**TOWN OF BROOKLYN
PLANNING AND ZONING COMMISSION
Regular Meeting Agenda
Tuesday, March 21, 2023 6:30 p.m.**

- a. Reading of Legal Notices:
 - b. Continued Public Hearings:
 - 1. **SP 22-008:** Special Permit Application for Multi-Family Development (50 Condominium units) on south side of Louise Berry Drive (Assessor's Map 33, Lot 19), 13.5 acres, R-30 Zone, Applicant: Shane Pollack and Erin Mancuso.

**TOWN OF BROOKLYN
PLANNING AND ZONING COMMISSION
Regular Meeting
Wednesday, March 1, 2023 6:30 p.m.**

Sheets 8-12 (Phasing Plans)

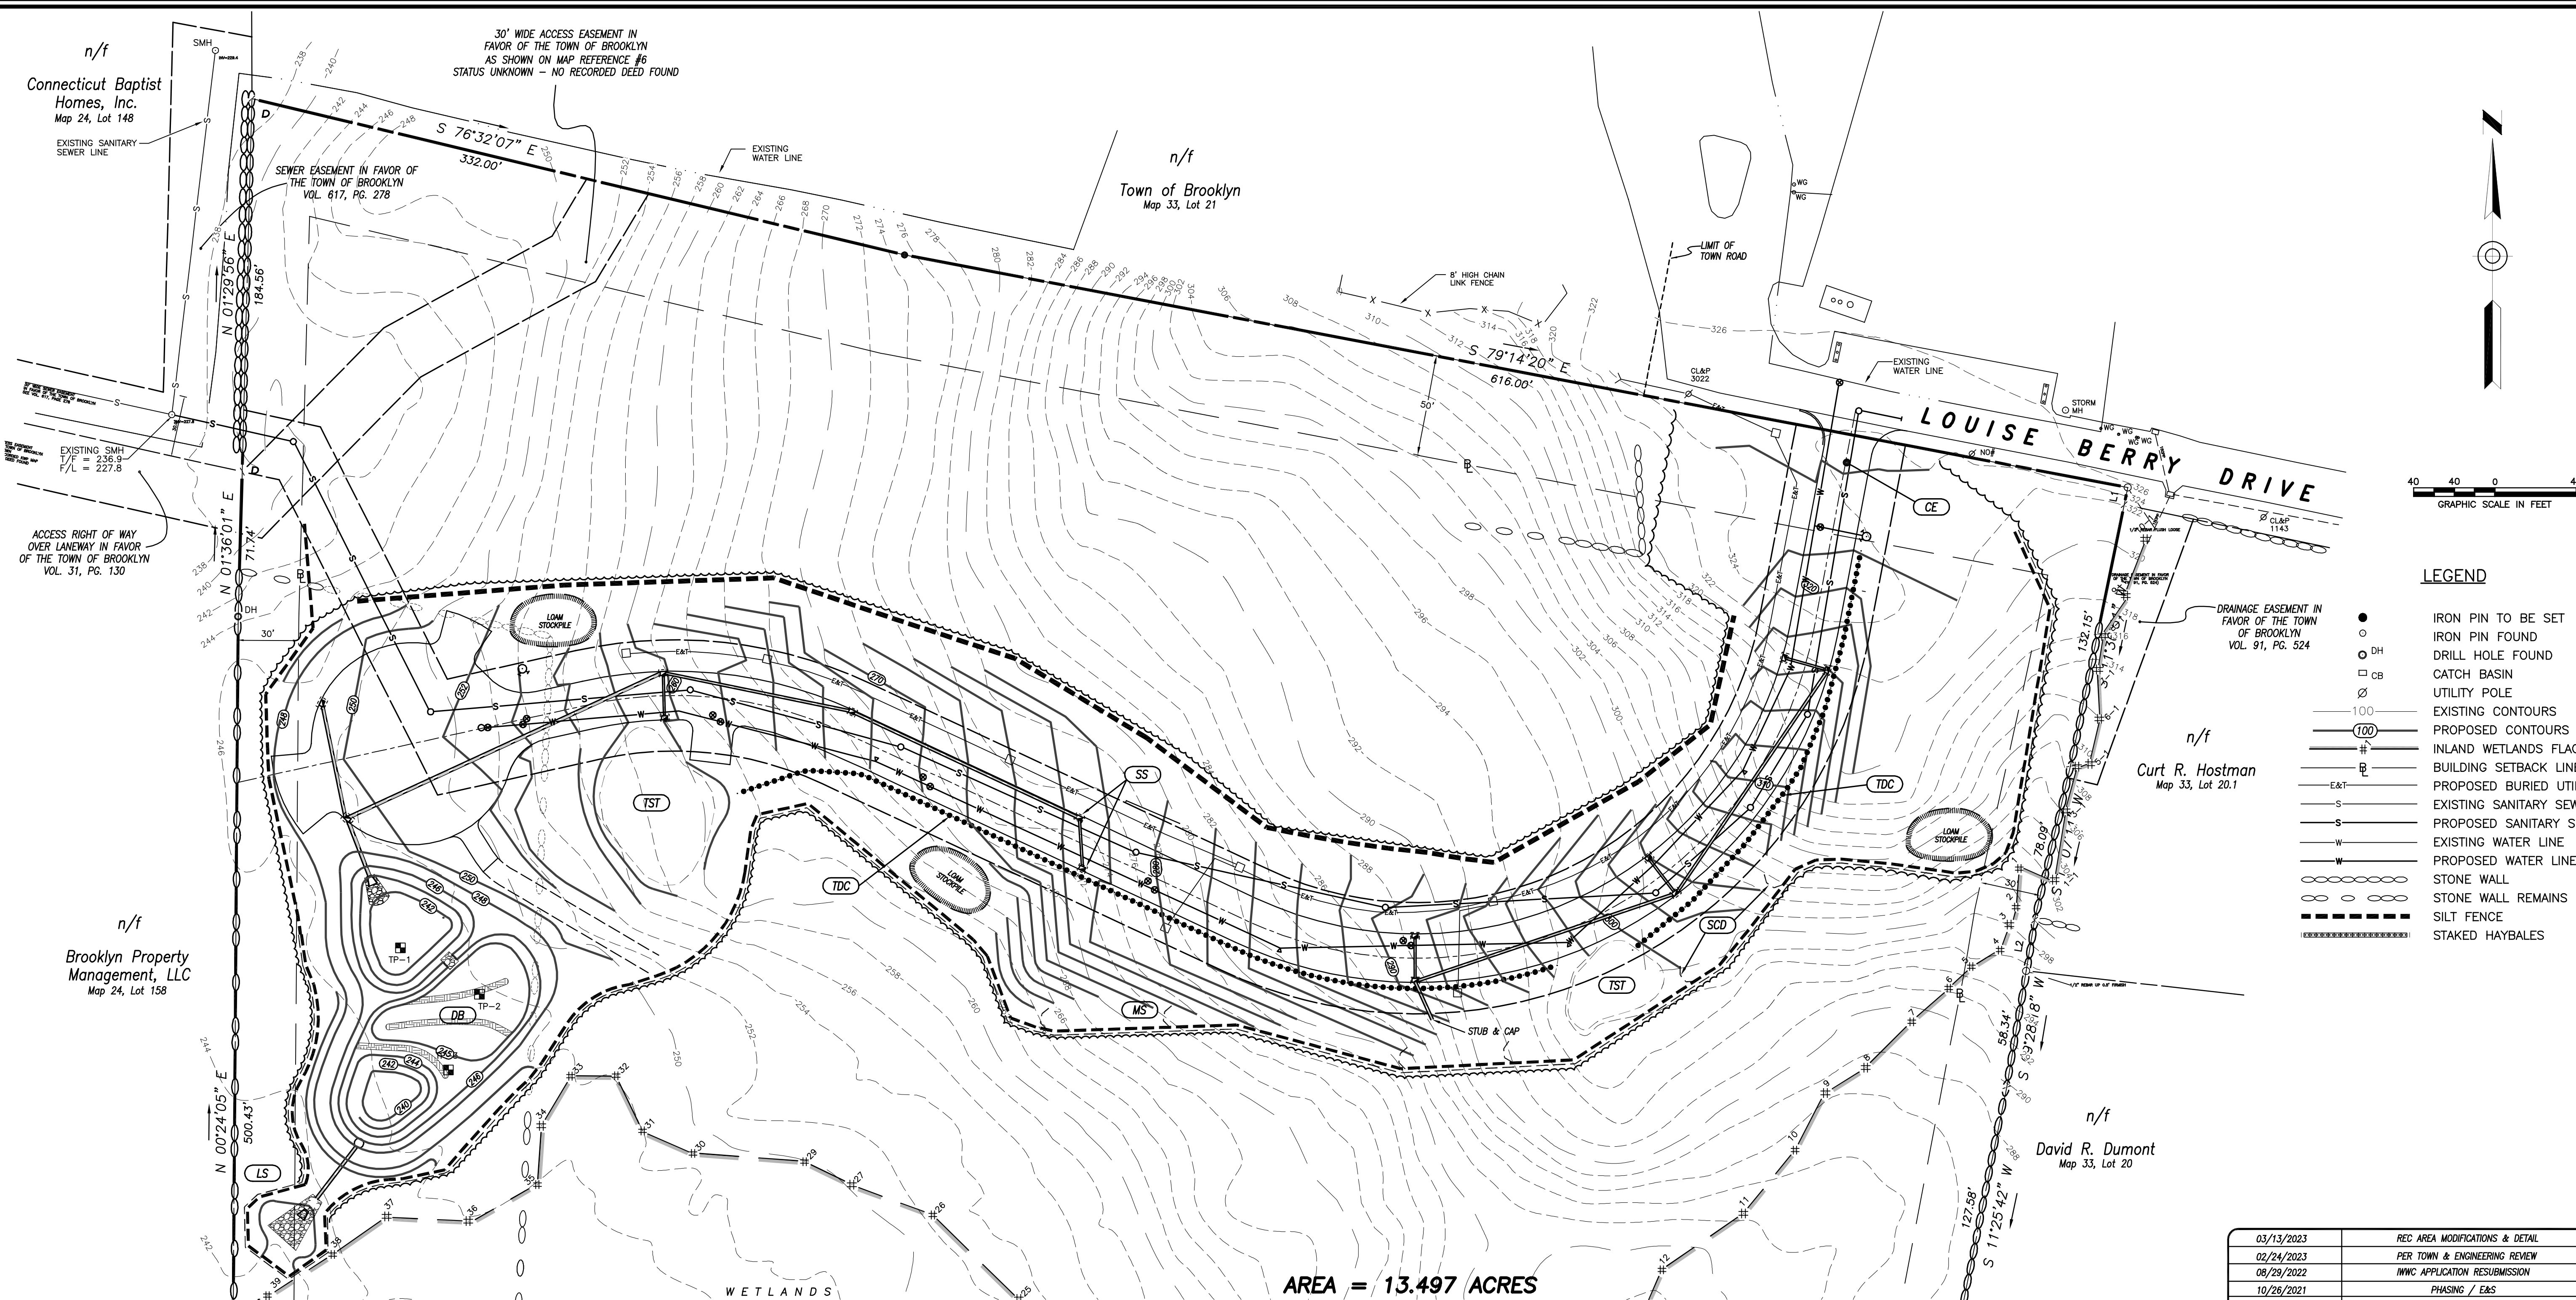
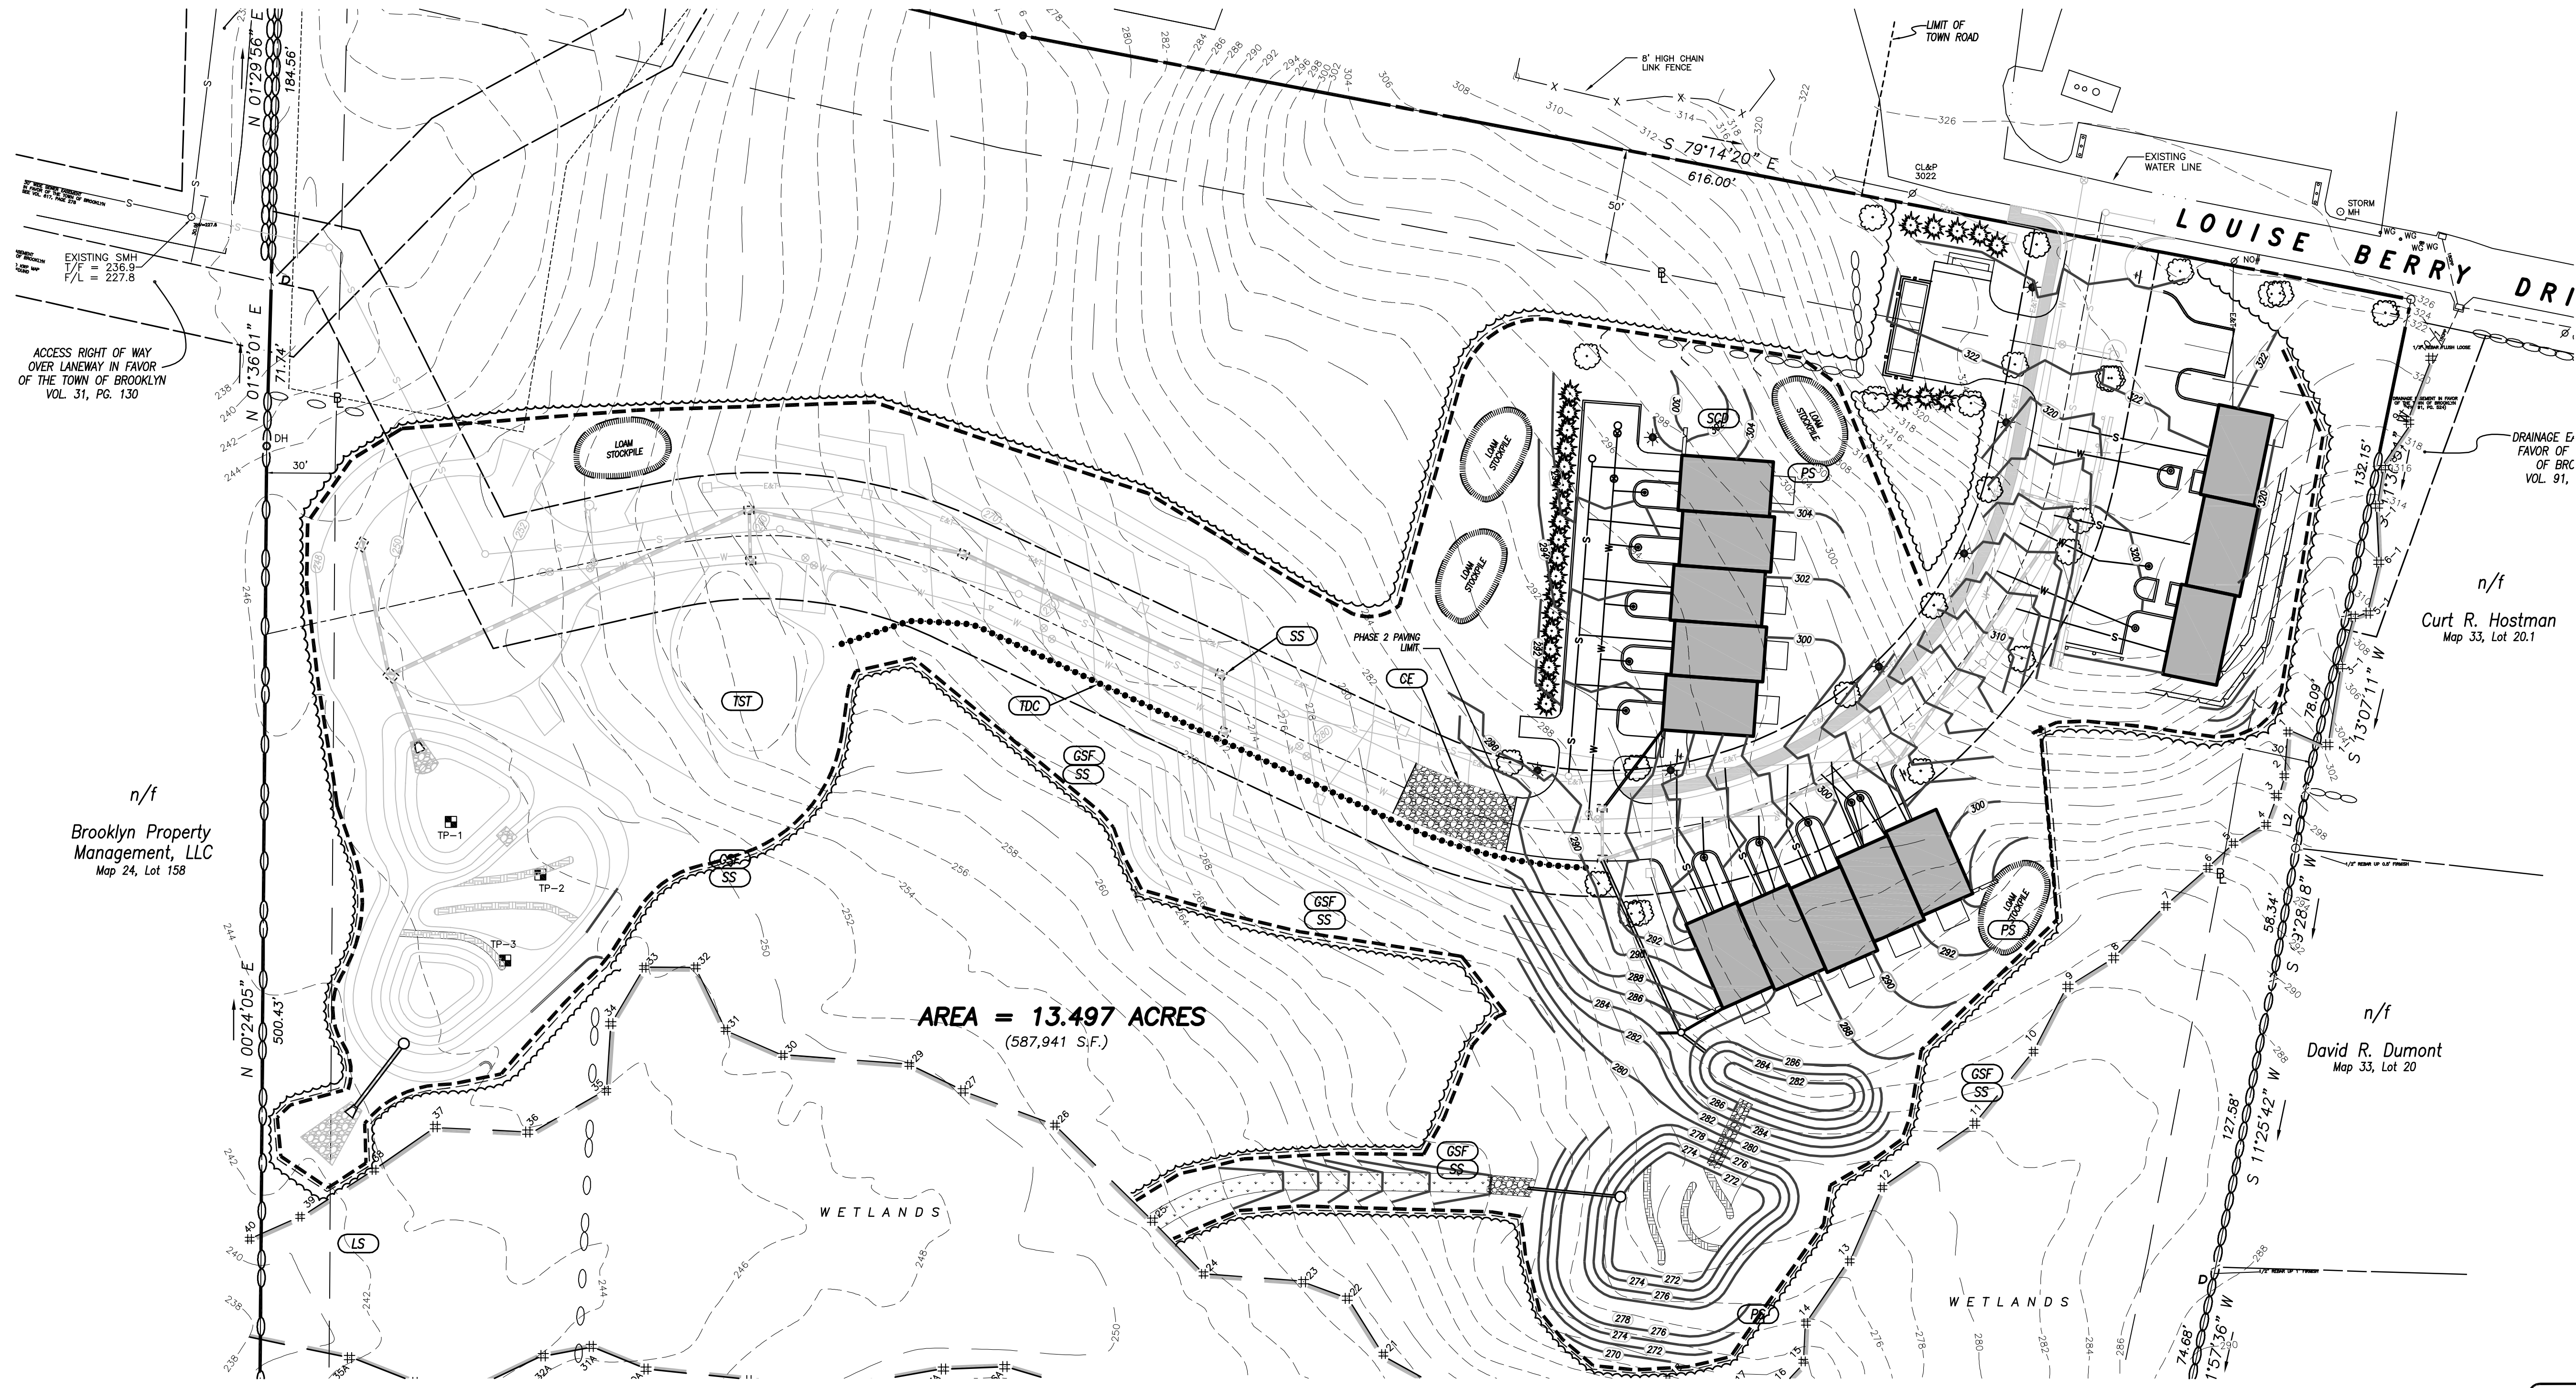
#1 - They are showing every phase to be paved. The sequence of construction on the Detail Sheet shows that the final course of paving will be installed upon completion of each phase.

#2 - They shaded the sidewalk areas on the phasing plans to make them more visible.

#3 - They added tree plantings to the phasing plans.

#5 - They added on-street parking to the phasing plans.

#6 - They added road centerline to the phasing plans.

#7 - They added stockpile areas to the phasing plans.

#8 - The proposed contour lines for the phases are a result of the final paving. He explained that there is a transition between phases as those contours have to be tied-into existing grades. He said that, for the most part, the contours are consistent with the overall plan.
